SNAPPER MINE

Northern Extension Modification

Submissions Report

JANUARY 2020
Project No. CMA-19-08
Document No. 01007985

Figure 3

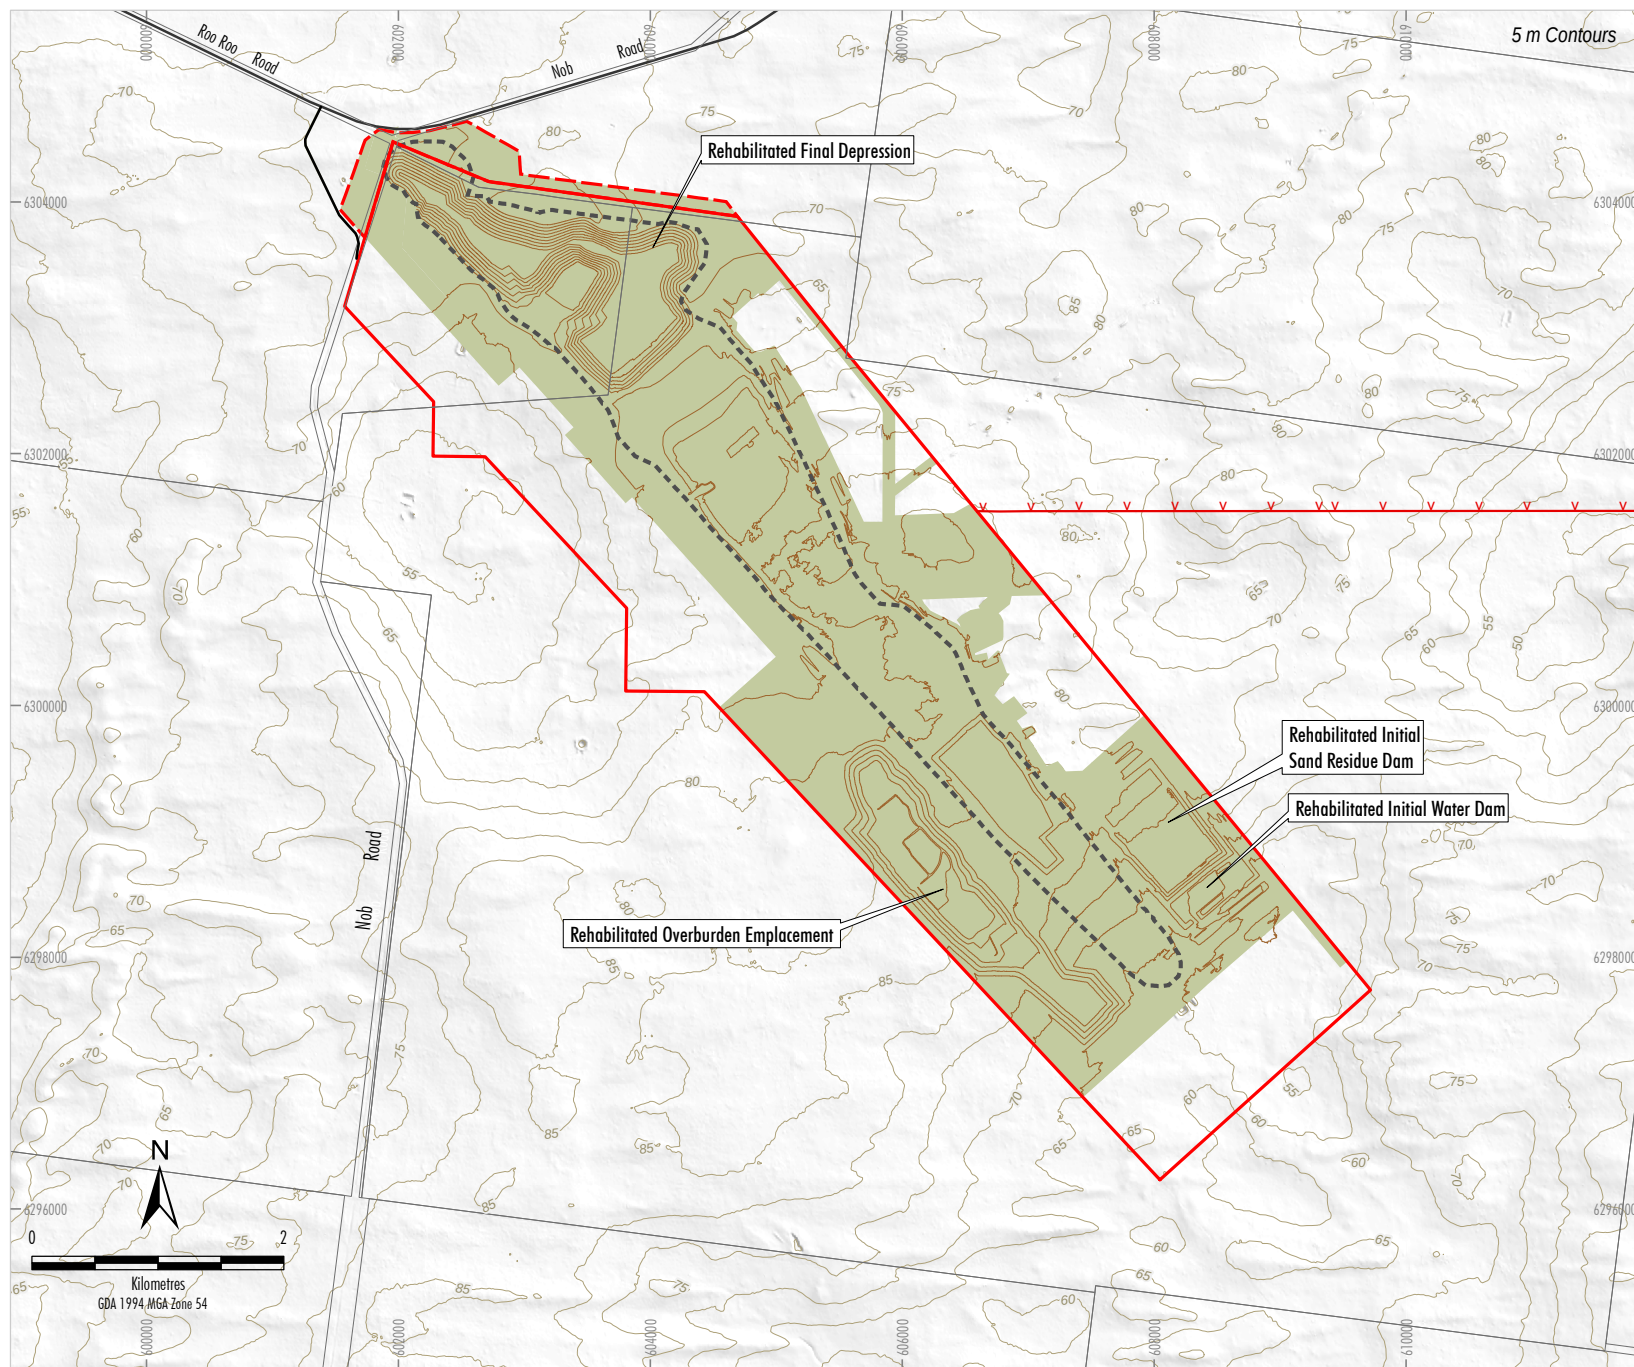
The DPIE requested that Figure 6 of the Modification Report be updated to include a scale and the increments of the surface contour lines shown on the inset.

The Manilla property leaseholders provided a comment regarding the rehabilitation of the Modification area (including a portion of the modified final depression) within the Manilla property, specifically in relation to the safety and suitability of the rehabilitated final landform for the approved final land use of light intensity grazing.

Figure 5 of the Modification Report has also been updated to show the increments of the contours lines and is provided as Figure 3.

As described in Section 3.1, as a result of ongoing consultation with the Manilla property leaseholders, Tronox would backfill the portion of the modified final depression inside the Manilla property so that it is level with the surrounding natural ground surface (Figure 3).

Figure 4

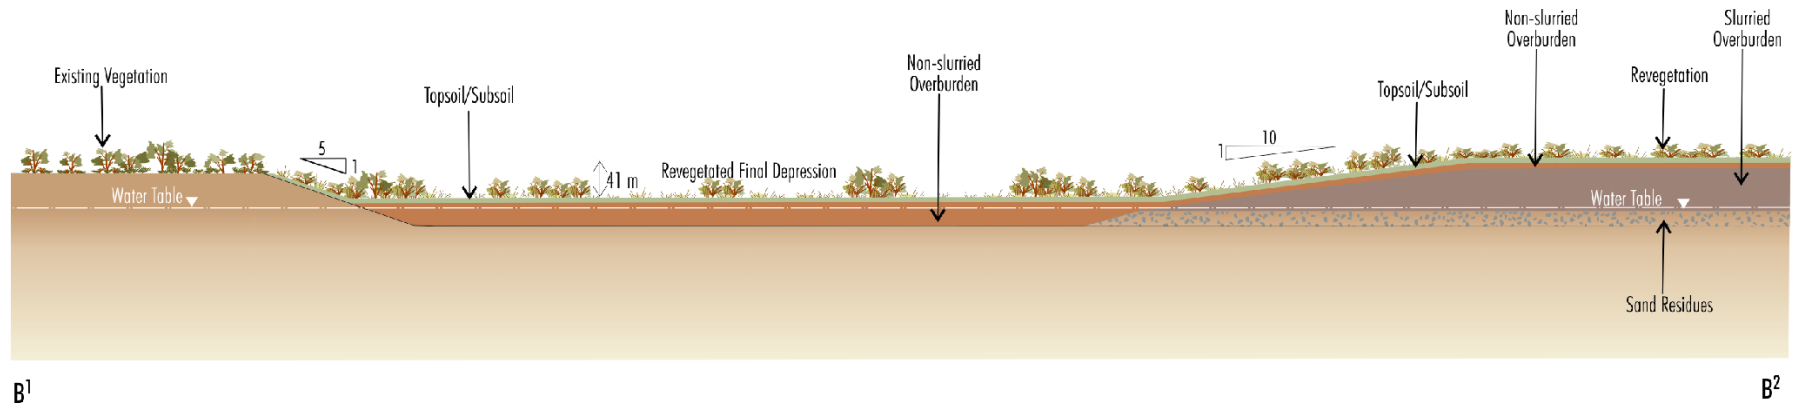
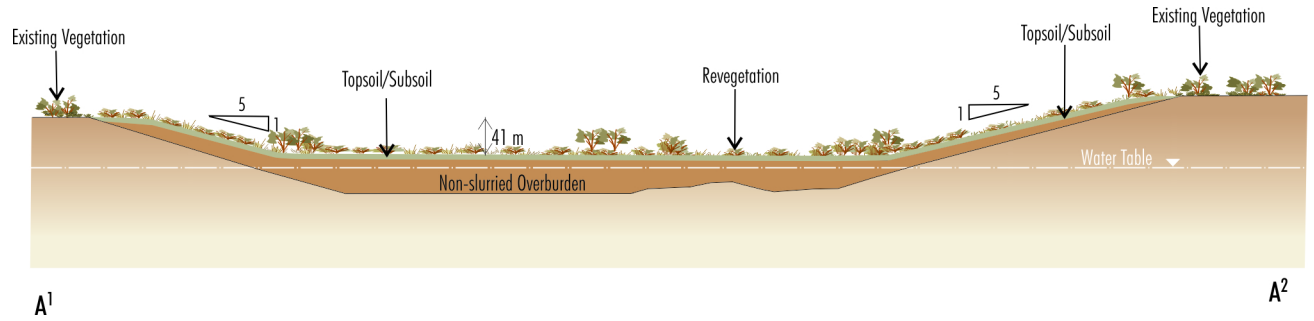
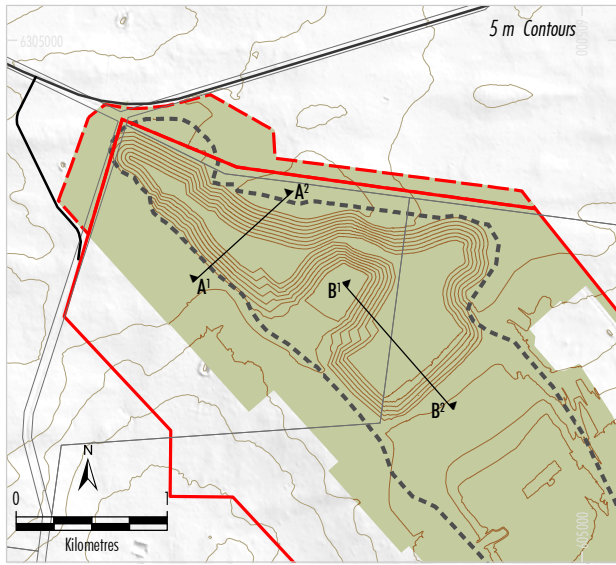
The DPIE requested clarification regarding the grade of the batter slopes for the modified final depression.

The slopes of the approved final depressions are 1:4. The Modification would reduce the grade of the batter slopes to between 1:5 and 1:10 (Section 2.5.2 of the Modification Report) (Figure 4).

Figure 6 of the Modification Report has been updated and is provided as Figure 4. Figure 4 shows the indicative final depression depth, batter slopes and the increments of the surface contour lines. Figure 4 also notes that the conceptual cross sections of the modified final depression are indicative only, and are not to scale.
